NSLPP MEETING HELD ON 04/10/23

ADDRESS:	96-98 Ben Boyd Road, Neutral Bay
APPLICATION No:	DA 86/2022/02
PROPOSAL:	Section 4.56 modification relating to development consent DA 86/2022 for consolidation of 2 lots, demolition of existing structures, excavation and construction of a six-storey residential flat building containing 21 apartments over two levels of basement parking and parking at grade, landscaping and associated works at 96-98 Ben Boyd Road, Neutral Bay.
MODIFICATION:	Changes to basement, services and plant rooms, basement parking, convert two storey apartments to single storey, internal layout changes, relocate communal room and entry stair, changes to platform lift and landscape terrace
PLANS REF:	Refer to Attachment 2 - Architectural Plans
OWNER:	Barbara Nancy Hazell (96 Ben Boyd Road) & Props of SP 61709 (98 Ben Boyd Road)
APPLICANT:	The Trustee for Aidop No.3 Unit Trust
AUTHOR:	Planning Ingenuity – Consultant Planner & Thomas Holman – Assessment Officer

DATE OF REPORT:	22 August 2023 (Updated 13 September 2023)
DATE LODGED:	28 April 2023
SUBMISSIONS:	None
RECOMMENDATION:	Approval

Figures 13 & 14 – Approved Level 4 Floor Plan, DA 2006 Rev C (left) and Proposed Level 2 Floor Plan, DA 2006 Rev F (right)

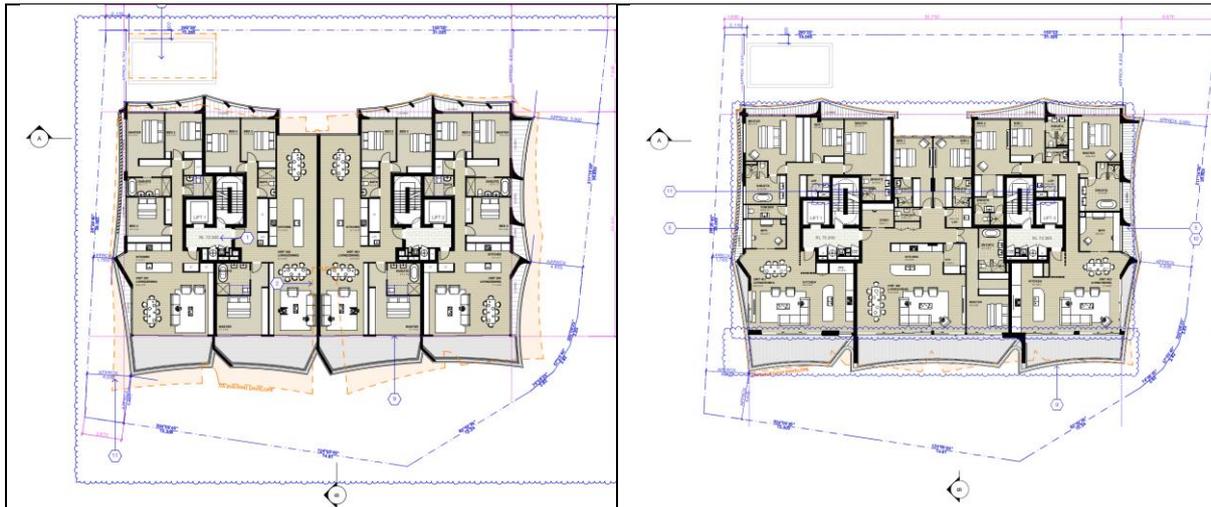
- Change internal apartment layouts
- Amendments to the design and size of the southern balconies
- 4 x 3-bedroom apartments converted to 3 x 3-bedroom apartments

Figures 15 & 16 – Approved Level 5 Floor Plan, DA 2007 Rev C (left) and Proposed Level 2 Floor Plan, DA 2007 Rev F (right)

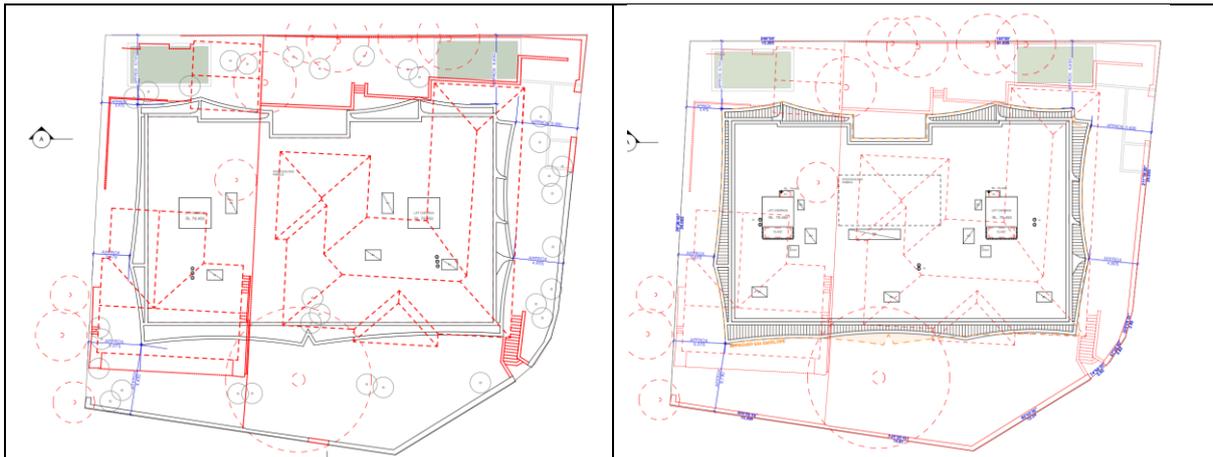
- Change internal apartment layouts (3 x 3-bedroom apartments to remain)
- Amendments to the design and size of the southern balconies
- Operate louvred screen added to Unit 501 western elevation

Figure 34 – Height Plane Diagram indicating additional screened rooftop plant (outlined dotted black), Dwg No. DA 9104 Rev F

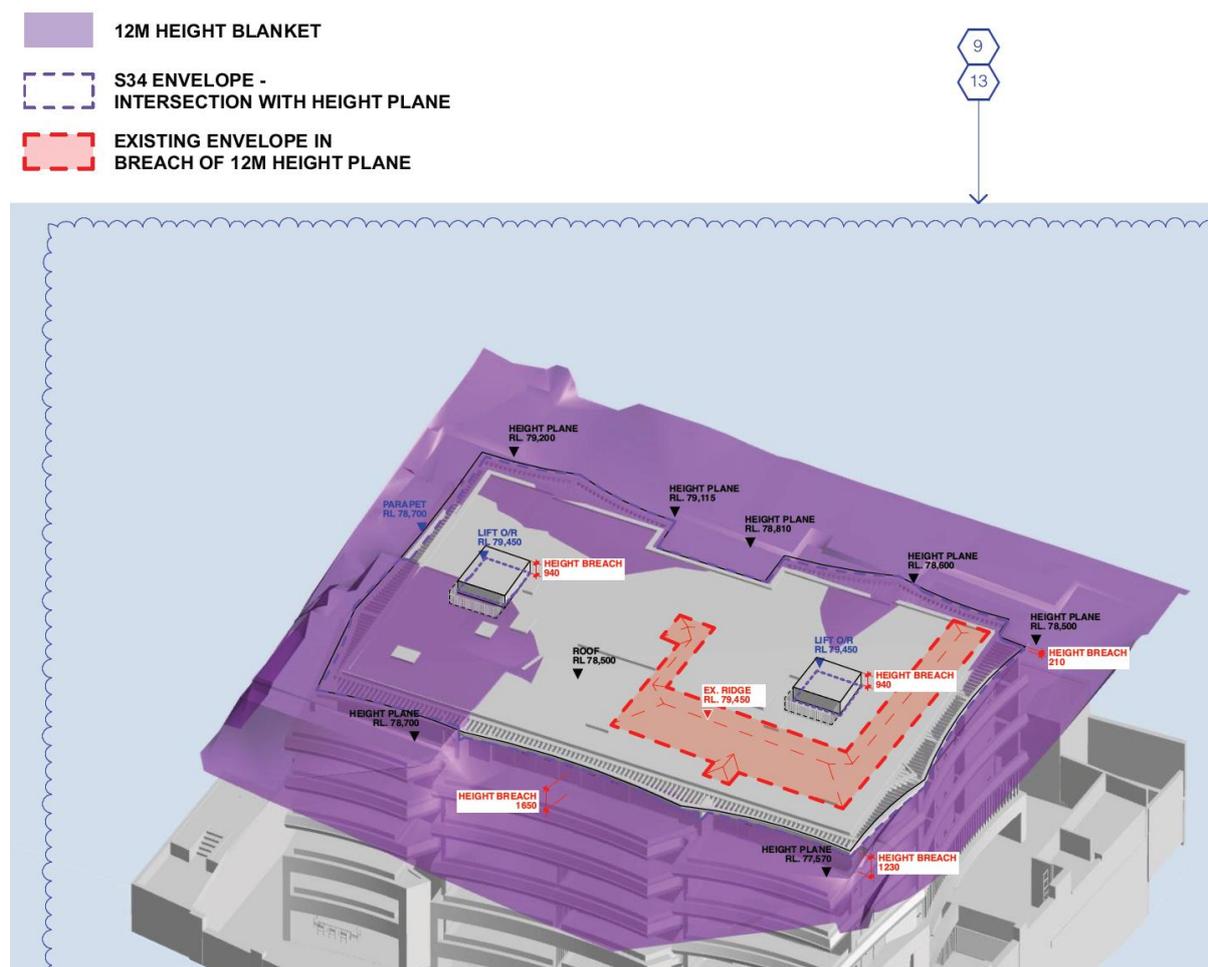
The proposed modifications include additional plant and equipment within screened enclosures on the rooftop and south of the two lift overruns. The plant and equipment enclosures will exceed the maximum 12m height of buildings control by a maximum 0.94m and will be the same height as the lift overruns to which the enclosures will be attached. The plant enclosures are located on the southern side of the lift overruns and will not add to any obstruction of views from the upslope apartments. The additional plant enclosures will be screened by rooftop landscaping and are recessed from the edges of the building footprint such that they will not be visible from nearby and adjoining public places. A revised height diagram is included in Figure 34 and revised view impact diagrams are included in Figures 35 and 36.

It is noted that the proposed modification involves no change to the maximum height of the building and a minor increase in the components of the building above the height control (being the additional enclosed plant areas adjacent to the southern side of the lift overruns as shown in Figures 6, 7 and 8).

Figure 37 – Comparative shadow diagram midwinter 9am, Dwg No. DA 9210 Rev F

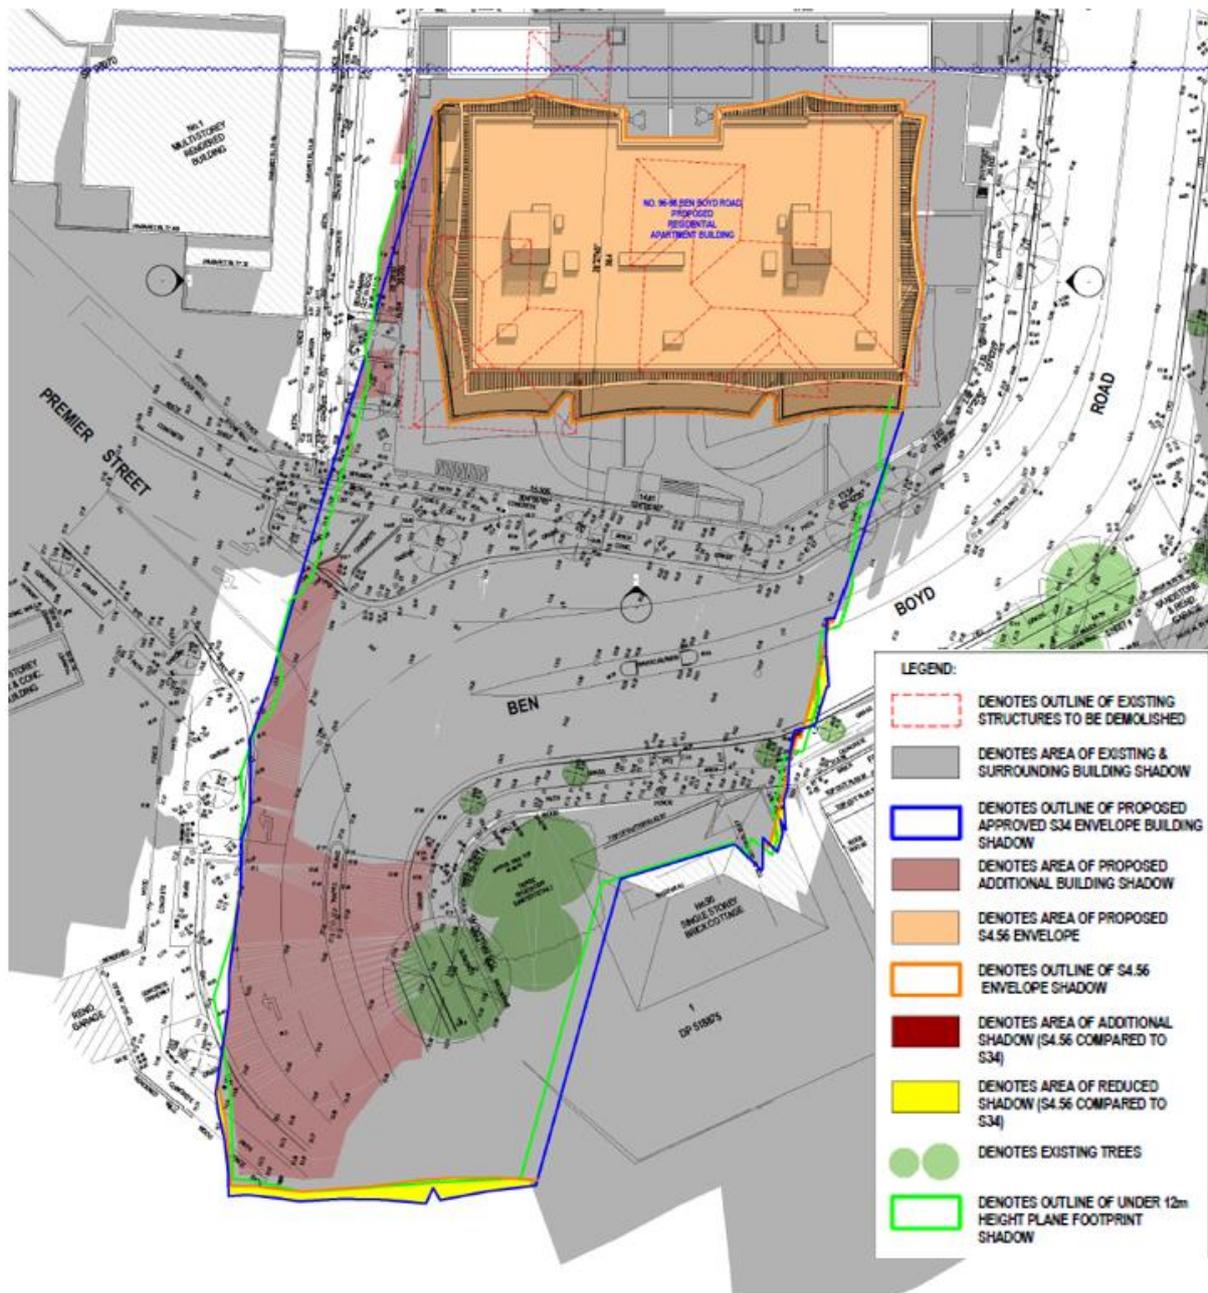
The additional rooftop plant enclosure will not give rise to any associated material environmental impacts because the additional plant area does not compromise compliance with development controls and objectives and will not result in additional overshadowing impacts as shown in Figures 37, 38 and 39 depicting midwinter, worst-case scenario shadow changes.

Figures 40, 41 & 42 – Approved Section B, Rev C (left), proposed modification Section B, Rev D (middle) and amended modification Section B, Rev F (right)

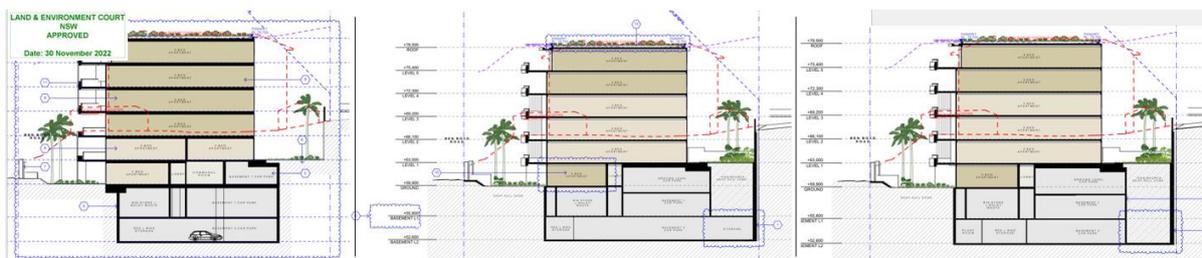
This modification application seeks to retain the Basement 2 Level at RL 52,600 and the rectangular deep soil area at the northern boundary will remain as required by Council following a preliminary assessment of the modification application. The footprint of the basement will extend to the southern side to accommodate improved circulation, provision of plant rooms and services facilities. The extended basement to the south is acceptable not having a significant increase in excavation and the additional excavation is offset by the reduced excavation required due to amendments to the basement entry/exit to Ben Boyd Road.

Figure 43 – Proposed modified Ground Floor Plan (DA 2002 Rev F) detailing amendments subject to Condition of Consent.

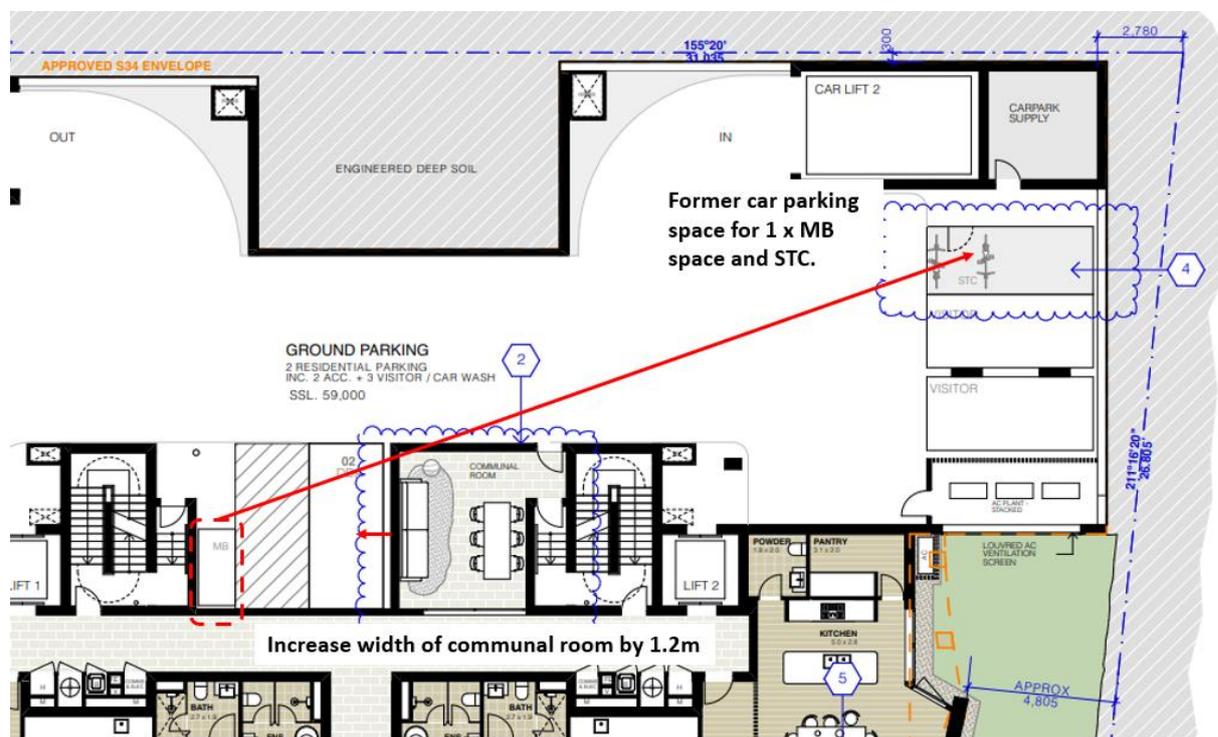
<p>C50. Ground Level Parking Design Change</p> <p>The communal room is to be enlarged to the west by approximately 1.2m, the DDA car parking space relocated to the west to accommodate for the enlarged communal room and the car parking space adjacent to the visitor car parking for use as a storage cage will be redesigned as both a space for motorbike parking and storage cage.</p> <p>Below are annotations detailing the proposed amendments subject to approval by Council’s Manager Development Services.</p>	
--	--	---	--

Figures 44 & 45 – Approved Site Coverage Diagram, DA 9103 Rev C and Proposed Modification Site Coverage, DA 9103 Rev D

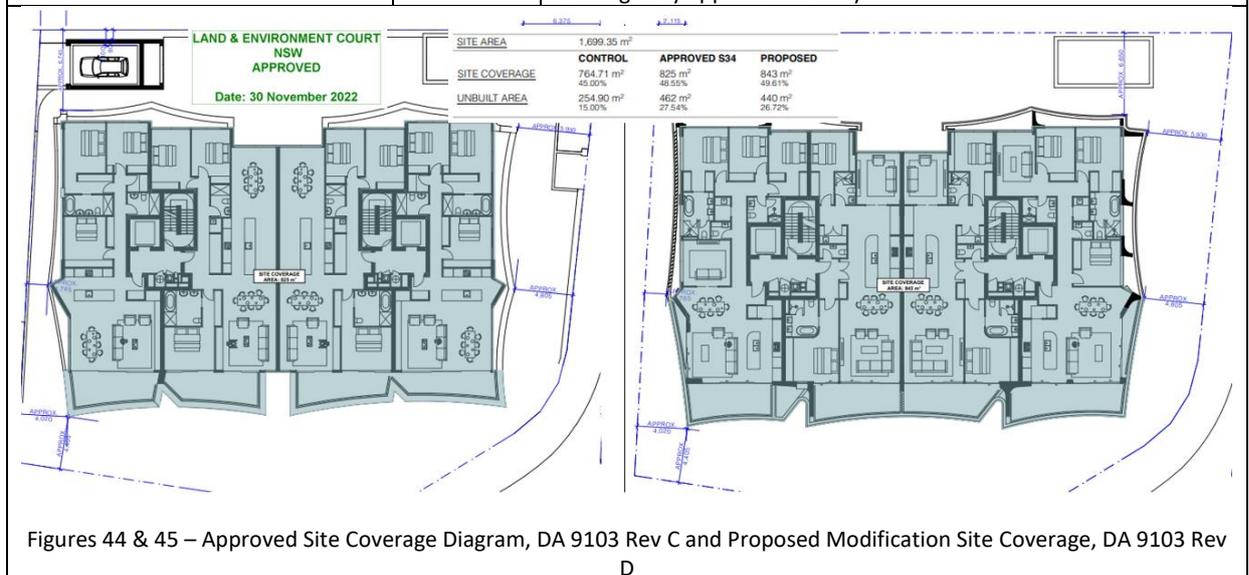
Section 1.5.5 - Site Coverage	Merit (Acceptable subject to condition)	The modification application seeks an additional site coverage of 18m ² increasing the site coverage exceedance to 49.61% which is 4.61% greater than the minimum 45% stipulated in Table B-1.6, s1.5.5 of NSDCP 2013. A request for amended plans to the applicant required amendments to the size of the balconies and a reduction in site coverage to not result in an increased site coverage noting the RFB as approved already exceeds the maximum 45% site coverage. Site coverage controls are identified in s1.8 'Introduction' of the NSDCP 2013 as a key development control to be complied with in any development and this was outlined to the applicant in a letter to the applicant dated 04 September 2023. It is recommended a design condition (C51 Balconies) is applied to the conditions of consent requiring deletion of the side balconies to revert to a louvre roof as originally consented and a deletion of the extended balcony on the western side of Level 5 serving Unit 501 to revert to the originally approved balcony.
